Columbia River Crossing

METROPOLITAN EXPOSITION-RECREATION COMMISSION

Subject: Interstate 5 Columbia River Crossing Draft Environmental Impact Statement

Attachment A
Expo Center Site Plan

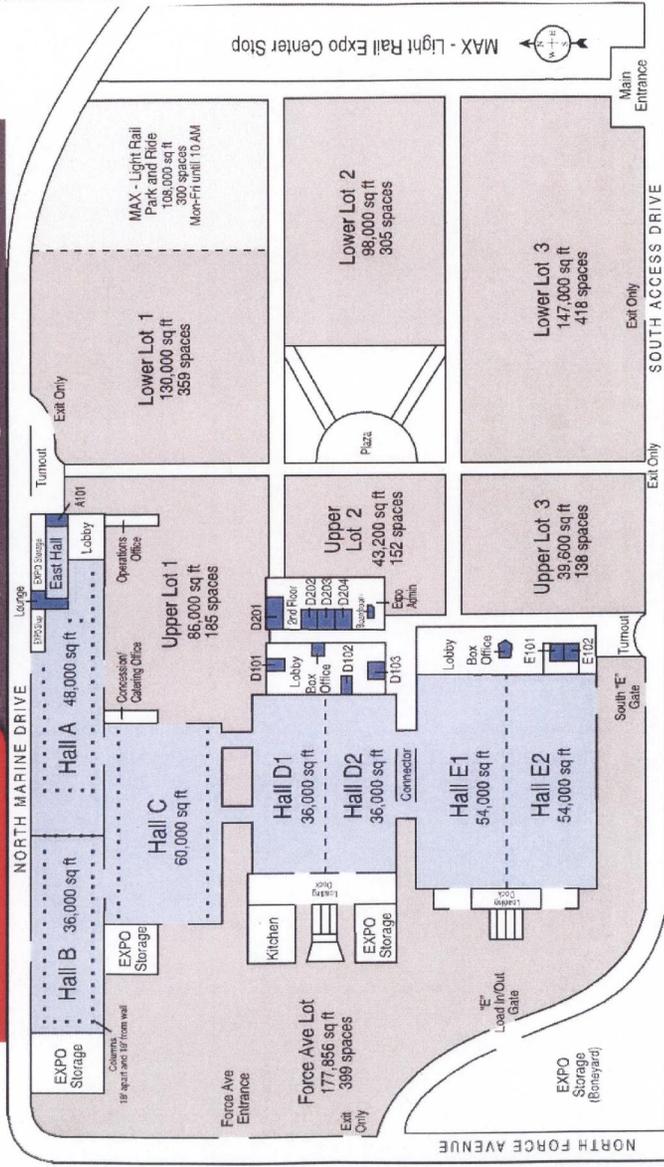
Our Expo Center complex, which is a 52-acre facility complex adjacent to the North Marine Drive interchange of I-5, is an important multi-purpose exhibition facility that has served as the region's primary destination for public events and consumer shows for more than 50 years (see Attachment A Site Plan). The facility consists of more than 330,000 square feet of exhibition space, 11 meeting rooms, professional catering facilities and parking for more than 2,500 vehicles. The Expo Center hosts approximately 100 events a year with more than 500,000 annual visitors. It is the largest and most successful exhibition facility of its kind on the West Coast and is a key economic driver for regional businesses, particularly small business.

- a) accommodates the large traffic flows that frequently occur during events;
 - b) does not sever a seven-acre, contiguous parcel of Expo Center property at the southwestern corner of the site which is used for loading and parking functions;

- m. How is useful access going to be provided to the southwestern seven-acre portion of the Expo Center site that is potentially severed by the southern alignment option?
- n. How would parking access and service road impacts at the southwestern corner of the Expo Center site be mitigated with the severing of the seven-acre corner parcel?
- o. What is proposed for the newly created developable land area directly east of the light rail station?

The Southern Alignment for the Marine Drive Interchange was not selected as the proposed design for this interchange. For a discussion about the proposed Marine Drive Interchange design, please see Chapter 2 of the FEIS. Impacts resulting from this design are discussed in Chapter 3 of the FEIS.
